NSD-NRC-97-5201  
DCP/NRC0927  
Docket No.: STN-52-003

SUBJECT: AP600 DESIGN CERTIFICATION, ADDITIONAL LEVEL OF DETAIL FOR SSAR  
SUBSECTION 9.4 AND SYSTEM DIAGRAMS, KEY ISSUE #1.

# ATTACHMENT 1 TO DCP/NRC0927

## **Attachment 2 to DCP/NRC0927**

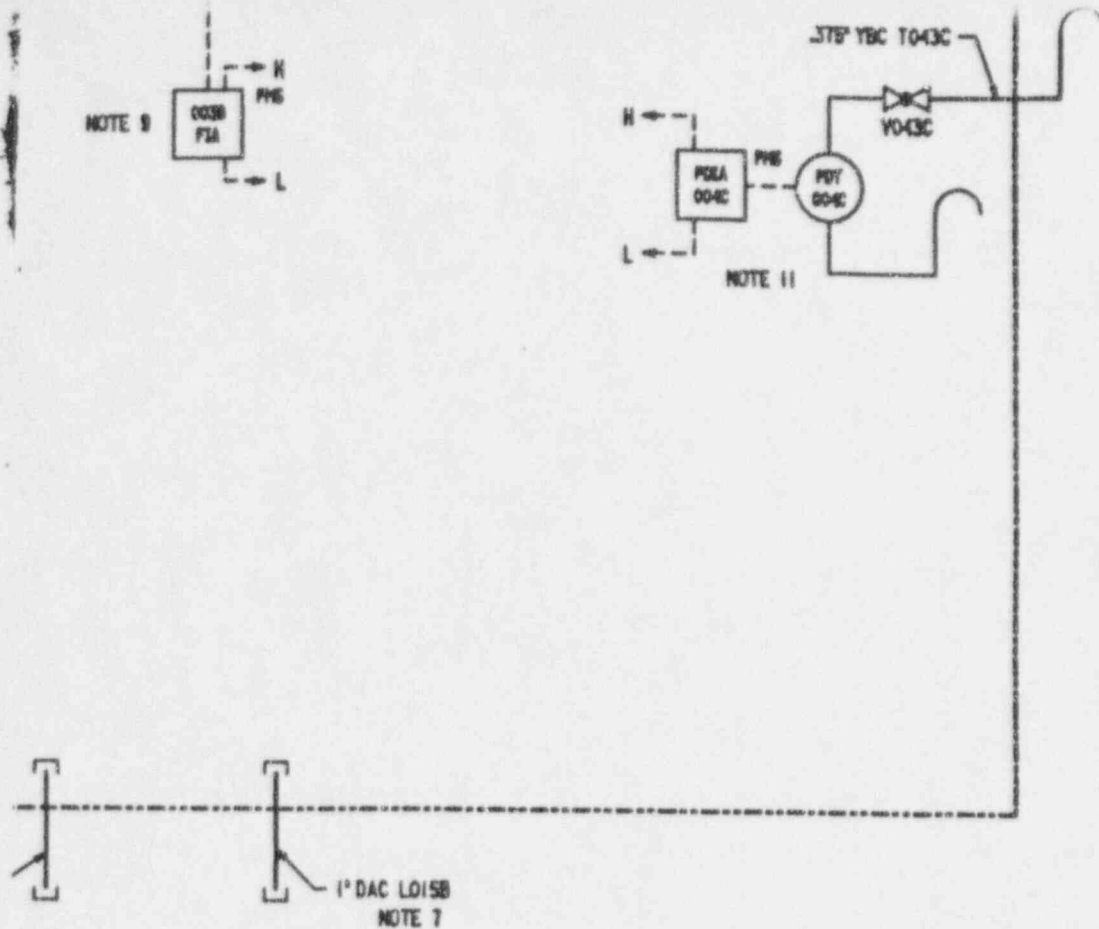
*"High-High" particulate or iodine radioactivity in MCR air supply*

- ~~Hi-Hi main control room radiation A~~
- Loss of ac power sources

#### 9.4.12 Combined License Information

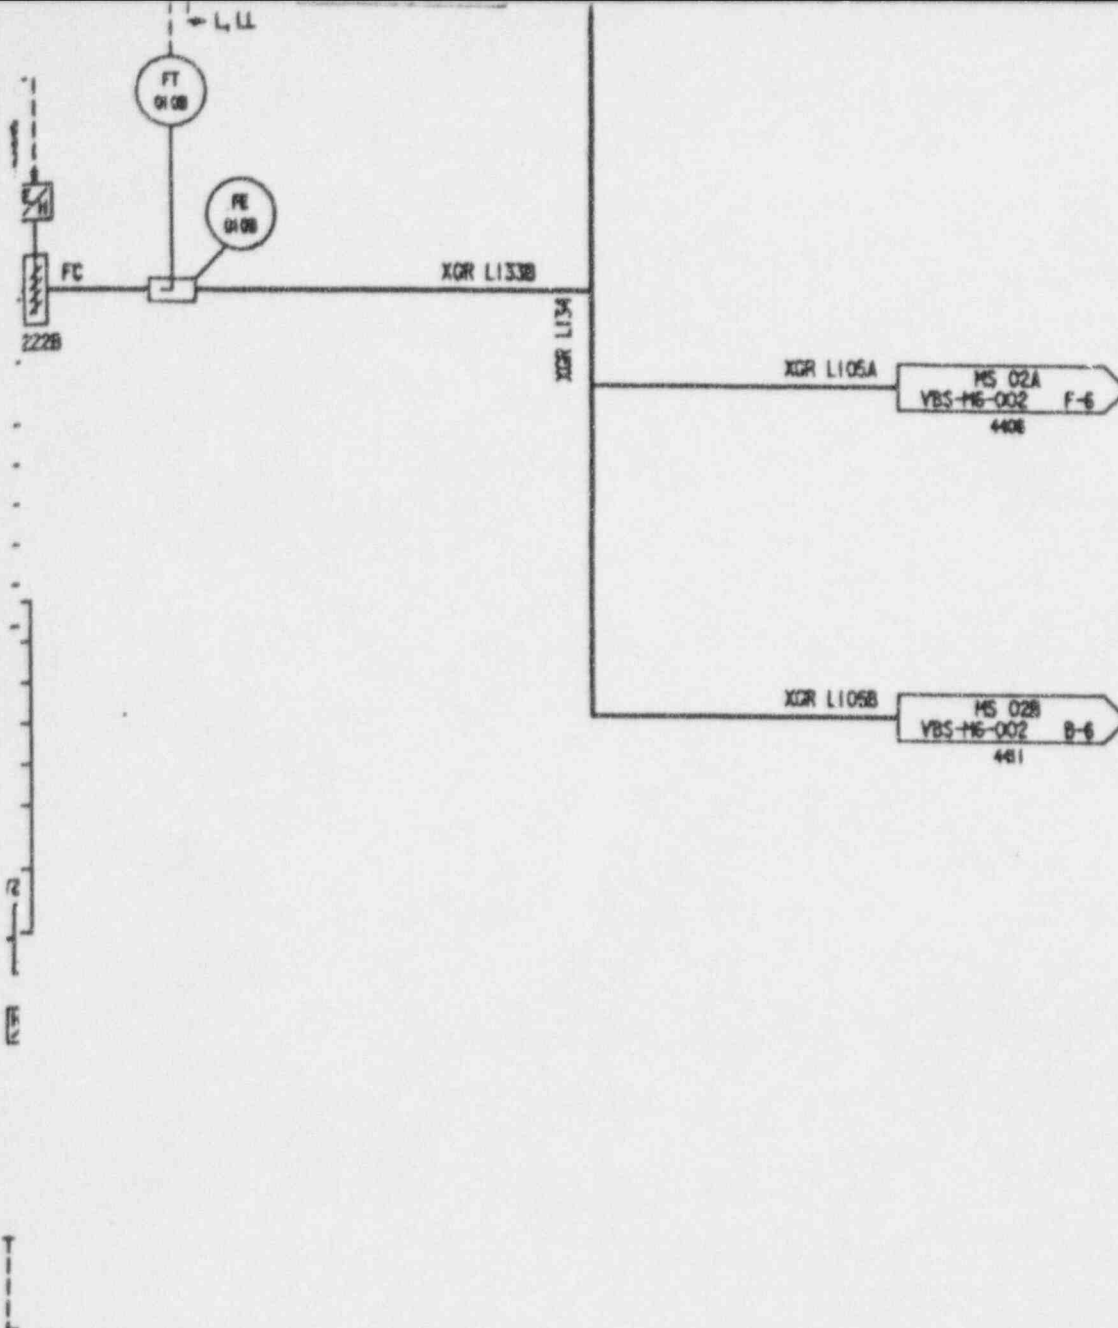
~~This section has no requirement for information to be provided in support of the Combined License application.~~

*The Combined License applicants referencing the AP600 certified design will implement a program to maintain compliance with ASME N509 (Reference 2), ASME N510 (Reference 3) and Regulatory Guide 1.44.*

Figure 9.4.3-1 (Sheet 2 of 3)

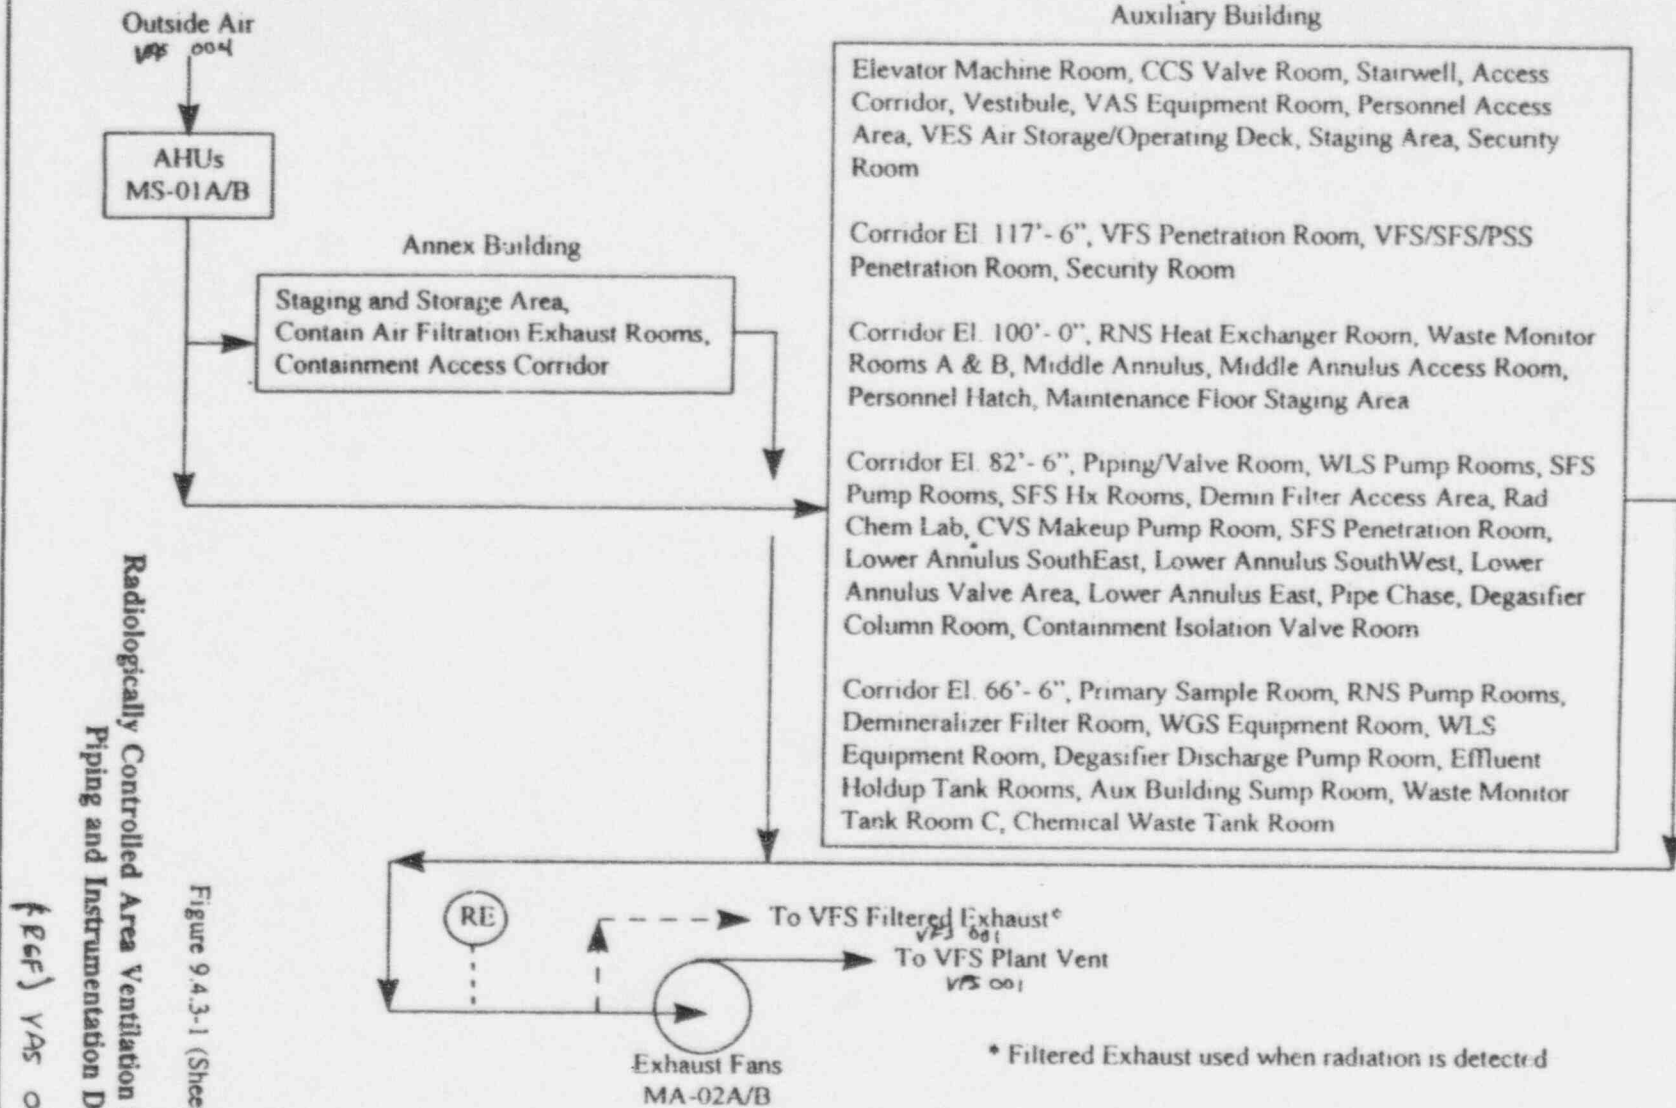
1.b	9.4-18, 9.4-24	See response to item 1.a.
1.c		See response to item 1.a. "TABLE 9.4.3-1" in this item in Attachment 1 to DCP/NRC0829 (NSD-NRC-97-5087) should be: "FIGURE 9.4.3-1".

The auxiliary/annex building ventilation subsystem serves radiologically controlled equipment, piping and valve rooms and adjacent access and staging areas. See Figure 9.4.3-1, sheet 2 of 3, for a complete listing of rooms and corridors serviced by this subsystem. The auxiliary/annex building ventilation subsystem consists of two 50 percent capacity supply air handling units of about 21,000 scfm each, a ducted supply and exhaust air system, isolation dampers, diffusers and registers, exhaust fans, automatic controls and accessories. The supply air handling units are located in the south air handling equipment room of the annex building at elevation 158'-0". The units discharge into a ducted supply distribution system which is routed through the radiologically controlled areas of the auxiliary and annex buildings. The supply and exhaust ducts have isolation dampers that close to isolate the auxiliary and annex buildings from the outside environment when high airborne radioactivity is detected in the exhaust air duct. The supply and exhaust ducts are configured so that two building zones may be independently isolated. The annex building staging and storage area, containment purge exhaust filter rooms, containment access corridor, and adjacent auxiliary building staging, equipment areas, and security rooms are aligned to one zone. The other zone includes the radiation chemistry laboratory, primary sample room, spent fuel pool cooling water pump and heat exchanger rooms, normal residual heat removal pump and heat exchanger rooms, CVS makeup pump room, lower annulus, middle annulus and various radwaste equipment rooms, pipe chases, and access corridors. A radiation monitor is located in the exhaust air duct from each zone.
